DATE: 01.16.2019
TO: ProTrak
FROM: Mitesh Baxi
Traffic Engineering

■ **ANSLEY PARK [TRC Plan Review]**

↻ Initial Review Note ↻

NCDOT:

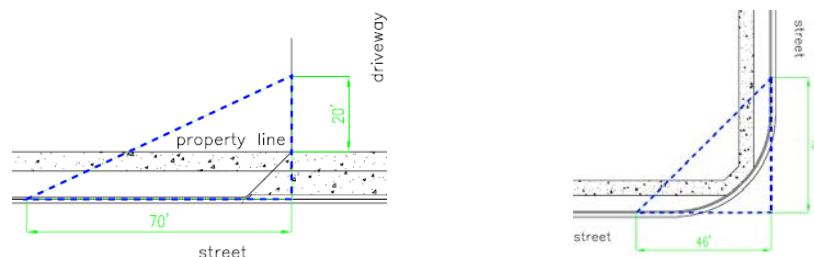
It is the Applicant's responsibility to coordinate directly with NCDOT to determine if any driveway permits/ revisions/ review processes are required. Contact NCDOT at 910-398-9100. Please note additional comments may be forthcoming once coordination occurs.
